Marine Scotland - Licensing Operations Team **Scoping Opinion**

Addendum: Marine Mammals

**SCOPING OPINION FOR THE PROPOSED SECTION 36 CONSENT AND
ASSOCIATED MARINE LICENCE APPLICATION FOR THE REVISED INCH
CAPE OFFSHORE WINDFARM AND REVISED INCH CAPE OFFSHORE
TRANSMISSION WORKS – MARINE MAMMALS ASPECTS ONLY**

Figure 1.1: Predicted dolphin distribution as per the Original Project ES (Option 1)

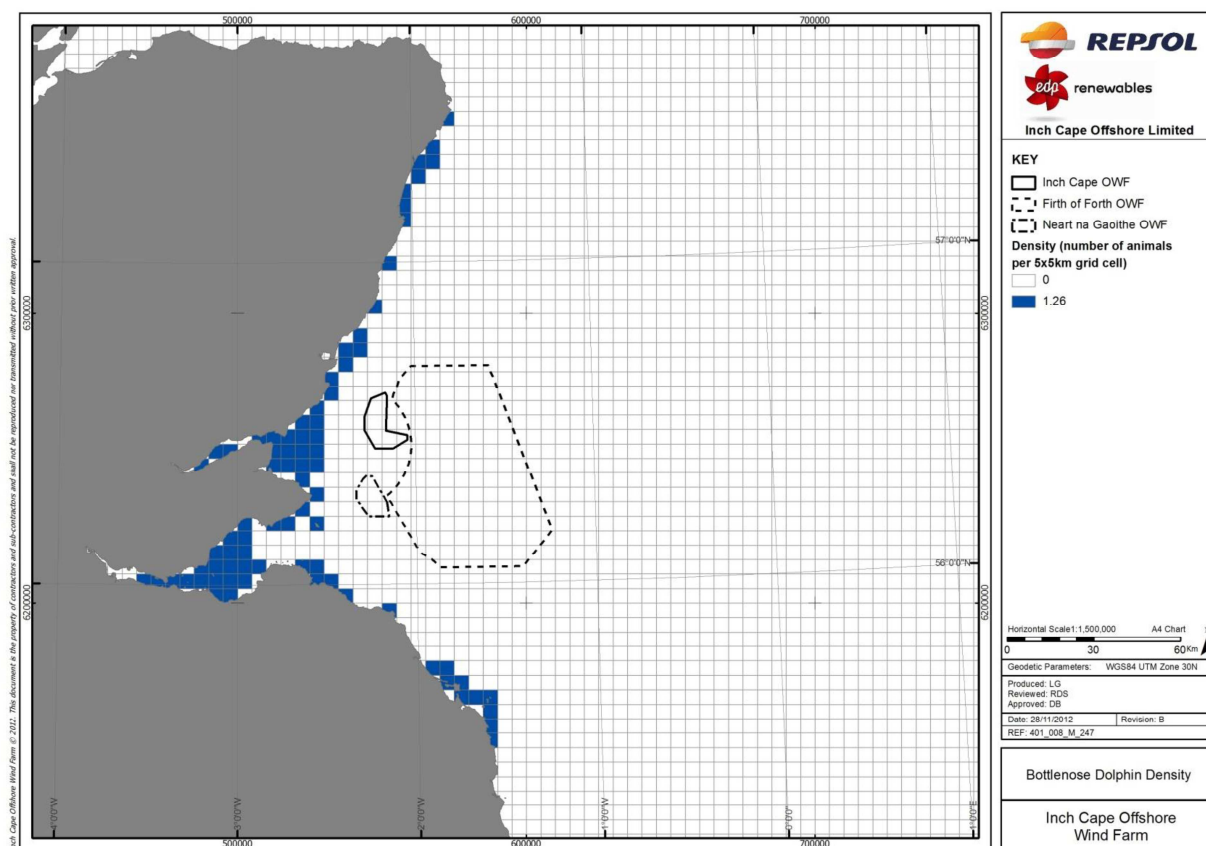
Option 1: As per the Original Project ES

1. Are we better to assume an uneven distribution of dolphins along the coastal strip?
2. If so, are we happy that the 'hotspots' are Latheron, Cromarty, Spey Bay, **Cruden Bay, Stonehaven, Arbroath**, and **St Andrews** (i.e. locations at which the proportion of days with dolphin detections was greater than 0.15 in two or more years).
3. If so, what dimensions should these 'hotspots' take? The grid cells used in the original ES were 5 x 5 km. Is this still appropriate? If we were to use this resolution for the revised assessment, how many grid cells should the hot-spots cover?
4. Should we assume that there are no dolphins between these hotspots?

<p><i>coast.</i></p> <p><i>Agreement reached that the 98 individuals assumed to be present off the east coast should be spread evenly across the area inside the 20 m depth contour as defined in the Original Development EIA, excluding areas in the Forth and Inner Tay where bottlenose dolphin are known not to be present (shaded red in Figure 1). These 98 animals will be spread evenly across the remaining grid cells (thereby increasing the density per grid cell).</i></p>

Figure 1

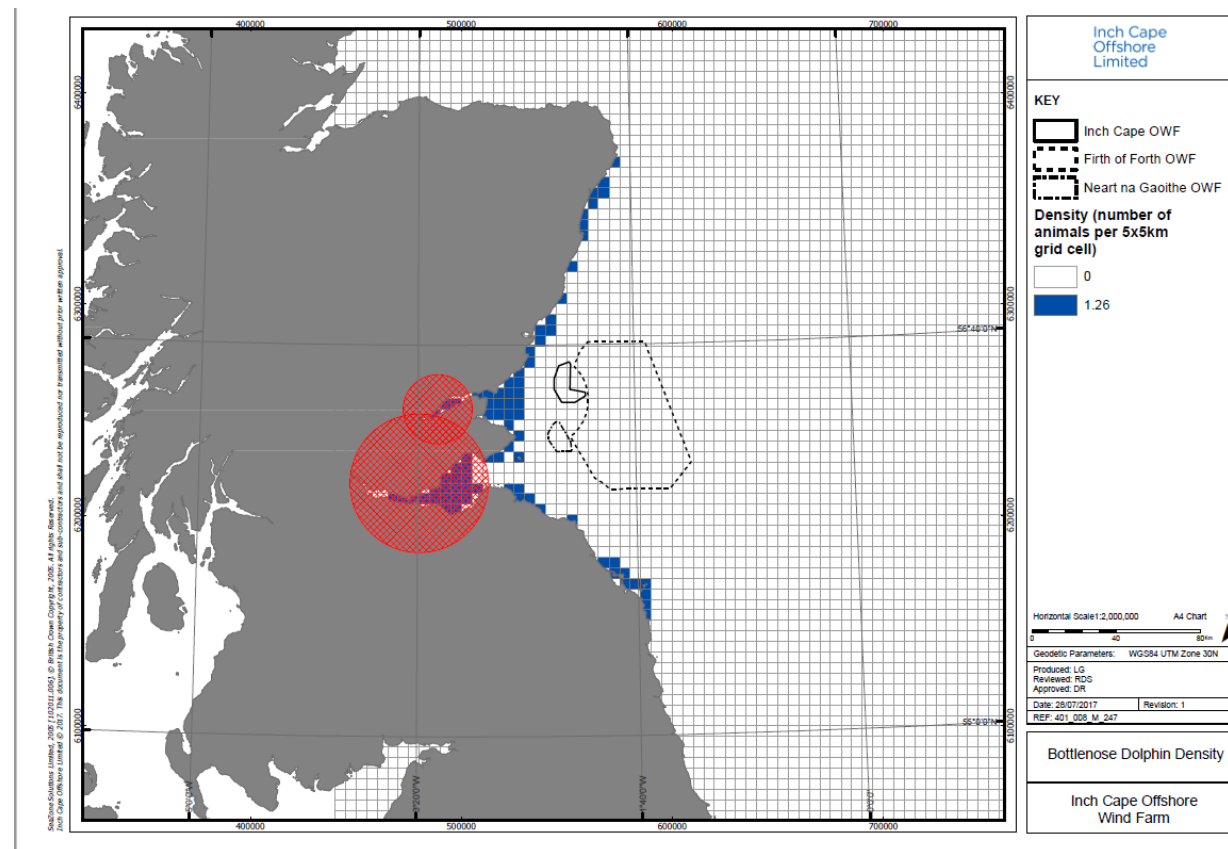
Forth and Inner Tay where bottlenose dolphin are known not to be present (shaded red in Figure 1). These 98 animals will be spread evenly across the remaining grid cells (thereby increasing the density per grid cell)."
